CHANGE ORDER

No. 4

TITLE: Two (2) Additional DC Breakers
 PROJECT/CODE: SGR397 - TPSS Component Replacement
 TO: C3M
 ATTN: Salvador Benitez

SUBJECT: 2 Additional DC Feeder Breakers

Proposed UTA TPSS/OCS Four (4) Breaker Configuration (Please zoom in on the TPSSs)

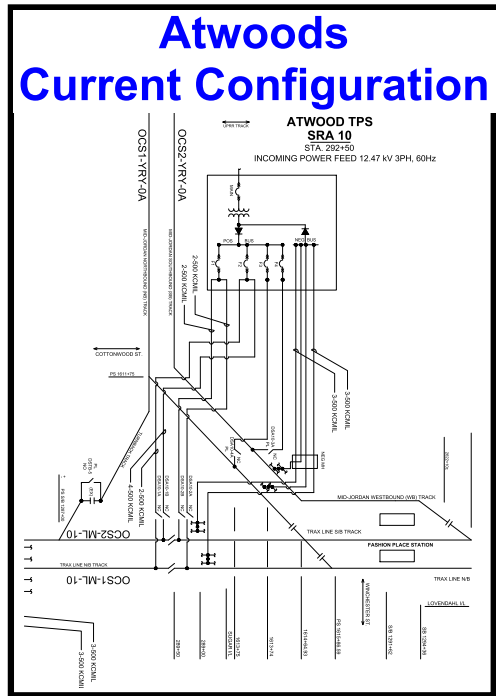
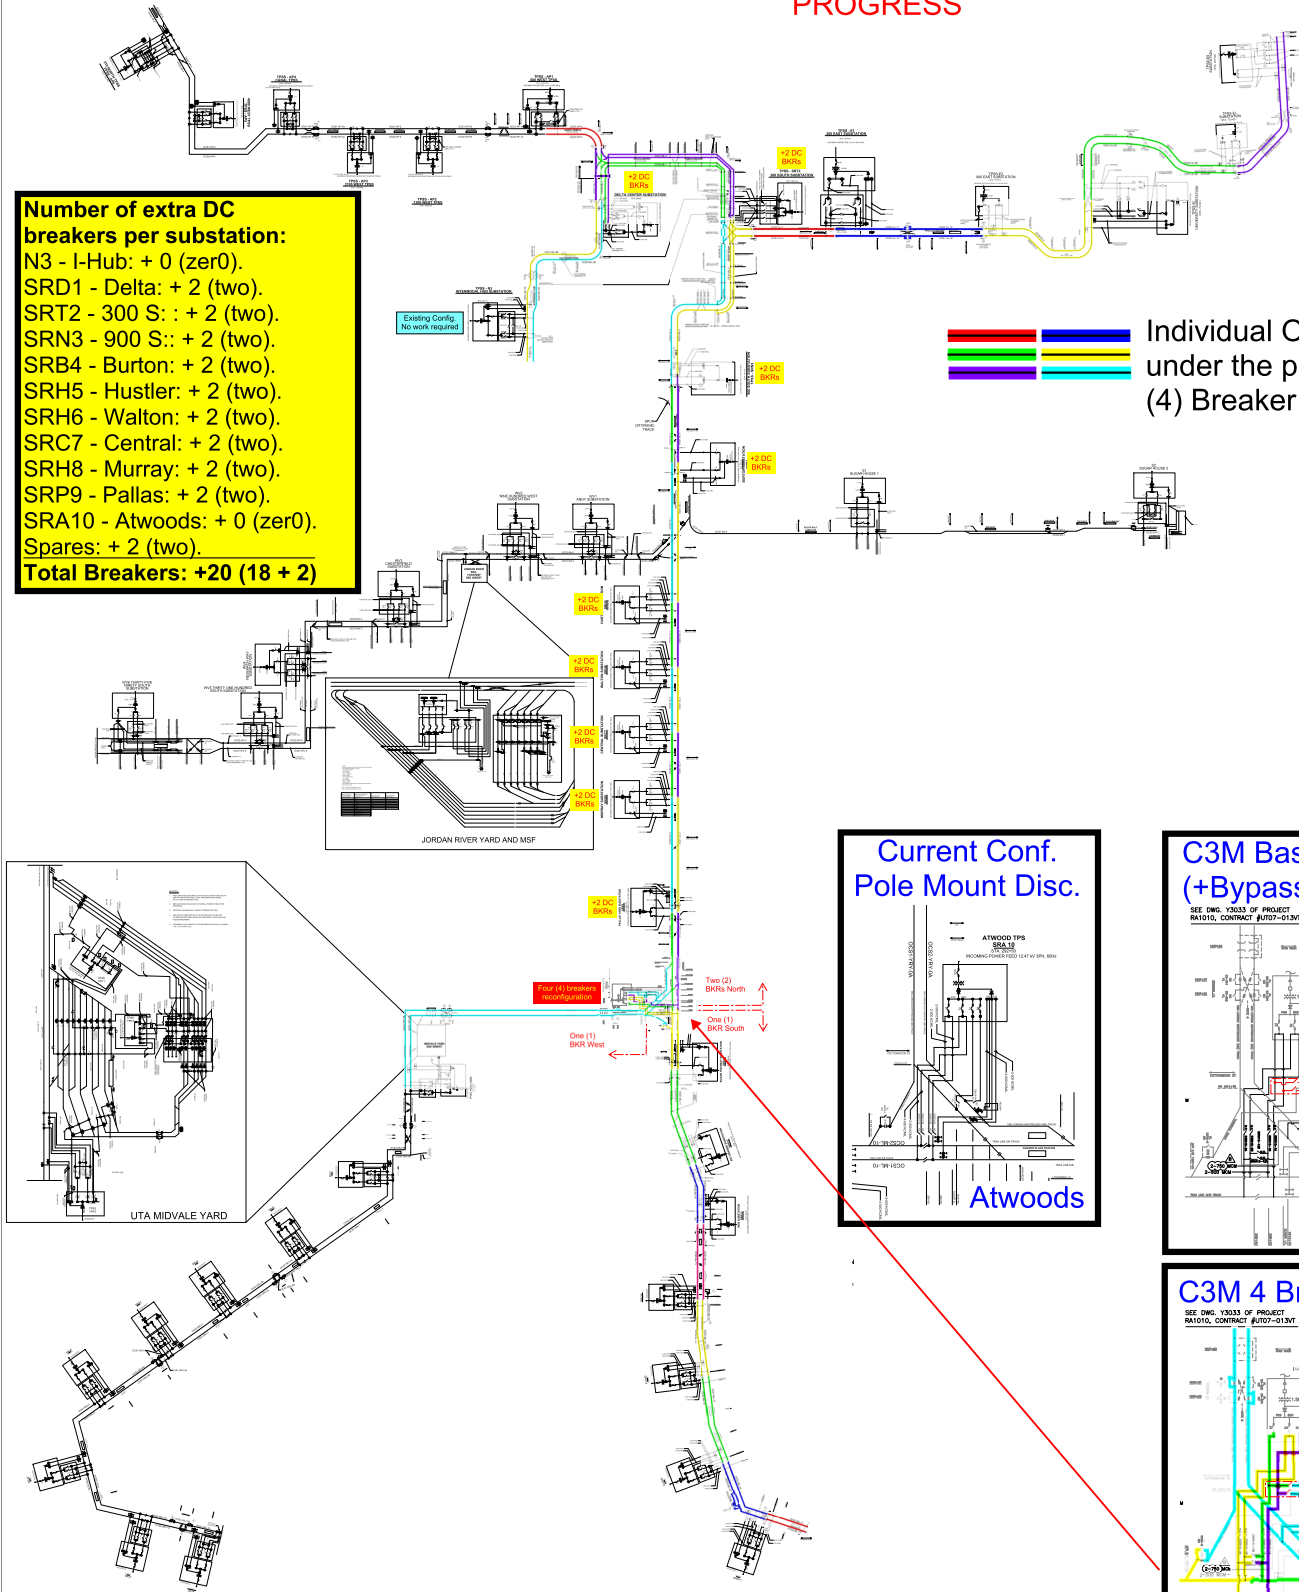
Area covered by the Four (4) DC Breaker per Sub Configuration

Number of extra DC breakers per substation:
 N3 - I-Hub: + 0 (zer0).
 SRD1 - Delta: + 2 (two).
 SRT2 - 300 S: + 2 (two).
 SRN3 - 900 S: + 2 (two).
 SRB4 - Burton: + 2 (two).
 SRH5 - Hustler: + 2 (two).
 SRH6 - Walton: + 2 (two).
 SRC7 - Central: + 2 (two).
 SRH8 - Murray: + 2 (two).
 SRP9 - Pallas: + 2 (two).
 SRA10 - Atwoods: + 0 (zer0).
 Spares: + 2 (two).
Total Breakers: +20 (18 + 2)

125VDC AND 120VAC DISTRIBUTION PANELBOARD SCHEDULES SCOPE A & B

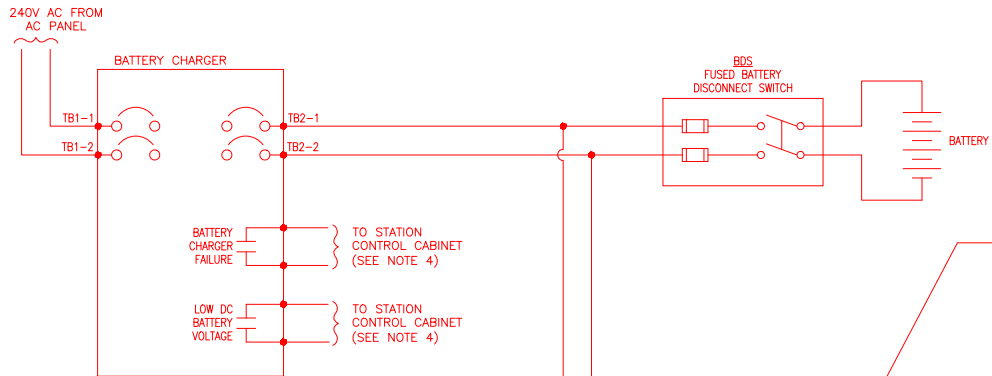
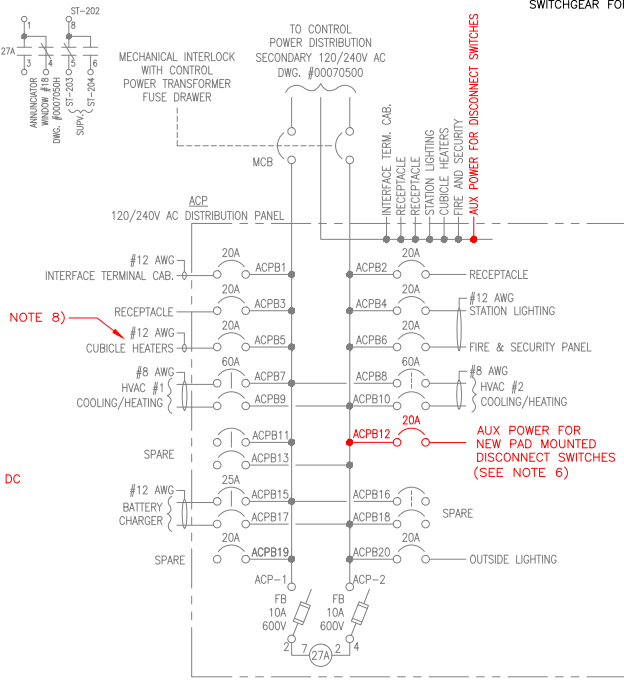
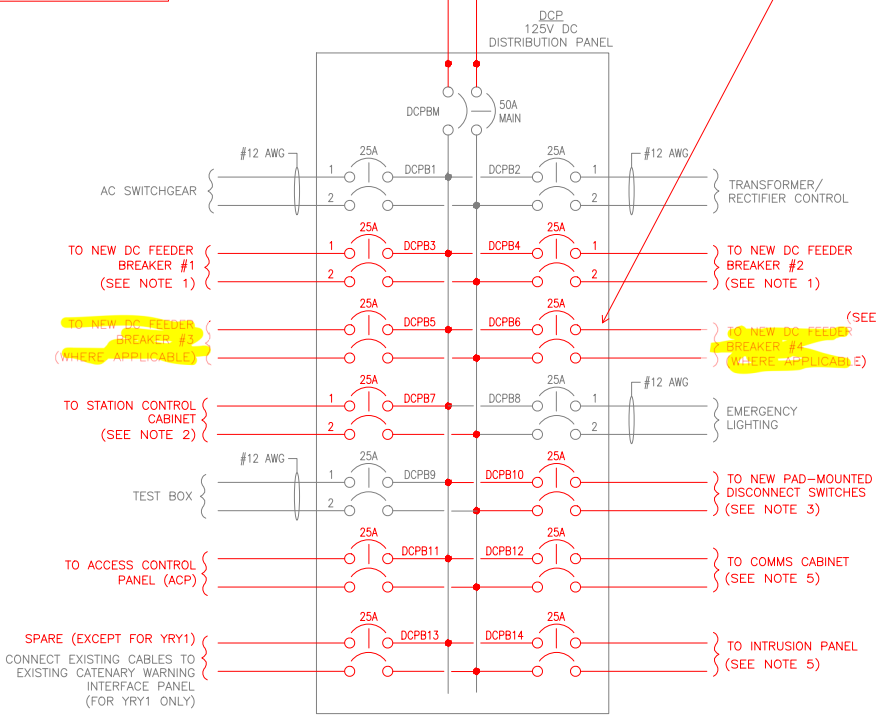
ADDITIONAL CONTROL WIRING

ADDITIONAL 125VDC CIR. Req. for Additional Breakers. Part of Added Scope

UTA REHABILITATION OF TPSS
NEW EQUIPMENT ARRANGEMENT PLAN SUBSTATION YR1 SCOPE B

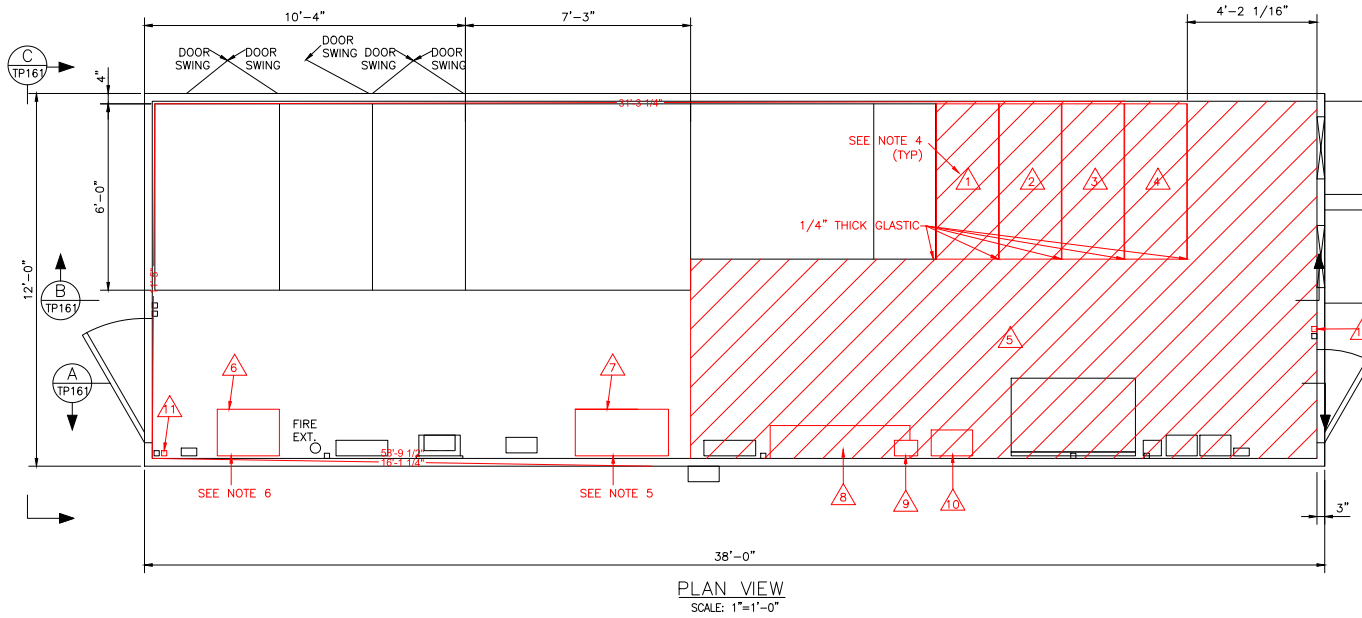
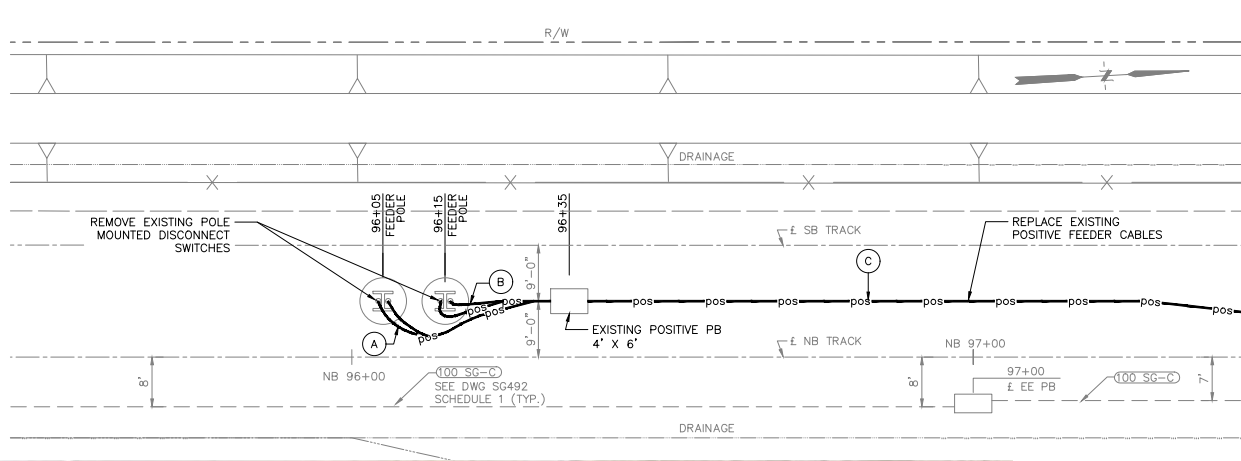
AVERAGE LENGTH OF CONTROL CABLE FROM NEW BREAKERS TO STATION CONTROL CABINET IS 60 LF

UTA REHABILITATION OF TPSS
9400 SUBSTATION
UNDERGROUND RACEWAY AND CABLE PLANS
TPSS SRN13
SHEET 1 OF 1

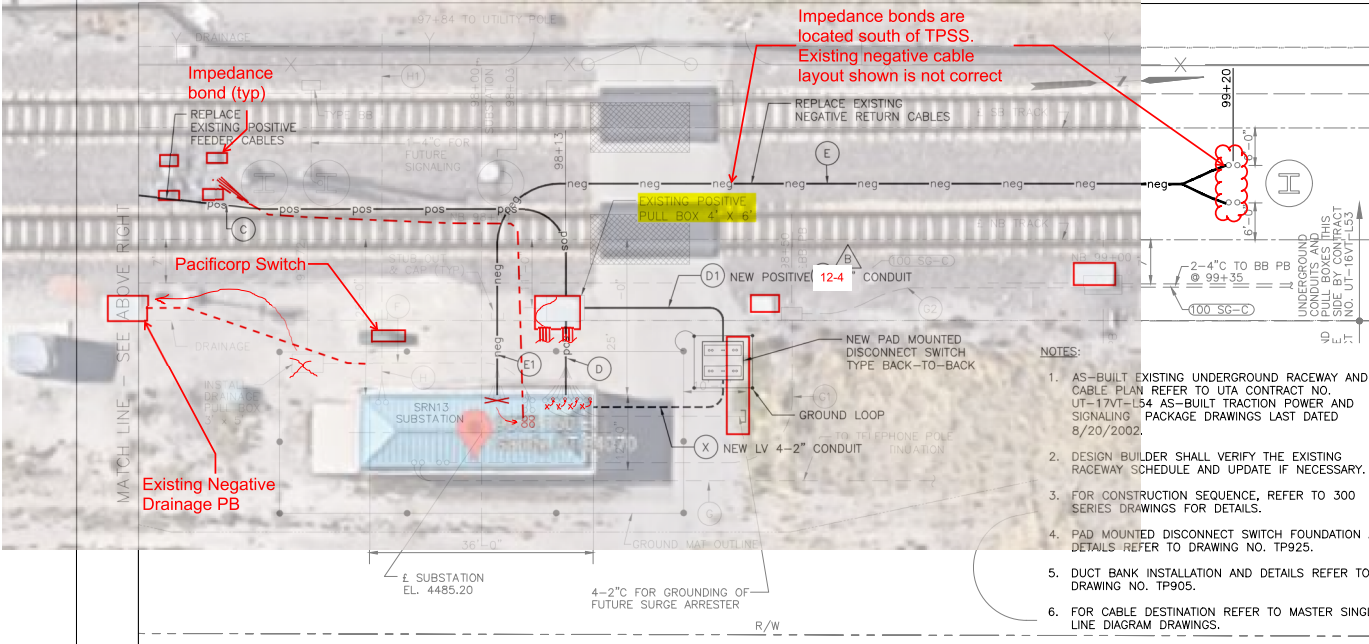
ADDITIONAL RACEWAY IN SCOPE

UTA REHABILITATION OF TPSS
DELTA CENTER SUBSTATION
UNDERGROUND RACEWAY AND CABLE PLANS
TPSS SRD1
SHEET 2 OF 2

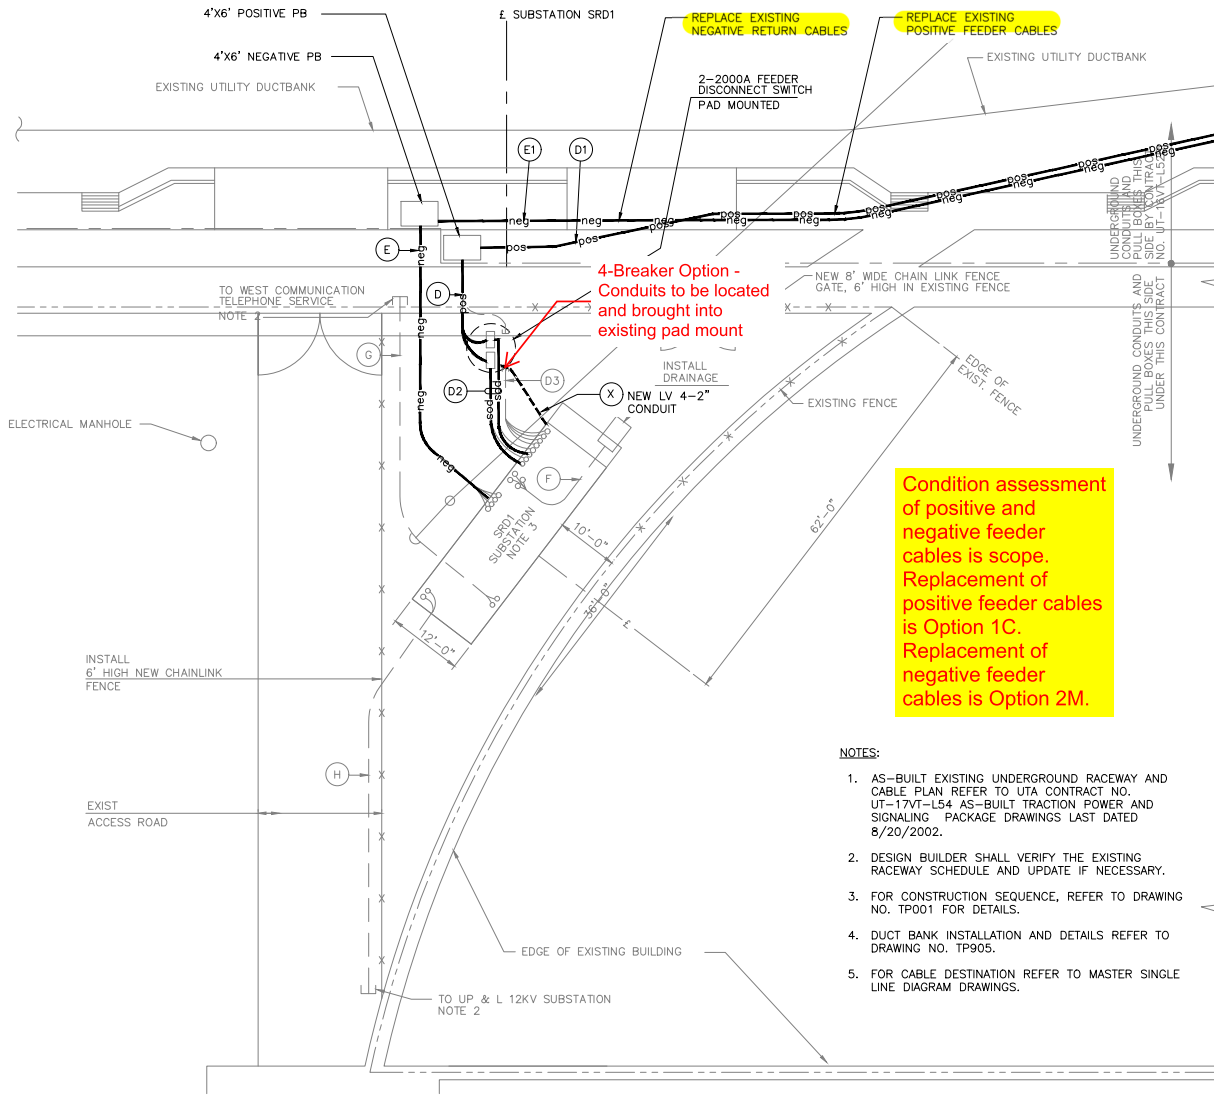
4-Breaker Option -
Conduits to be located
and brought into
existing pad mount
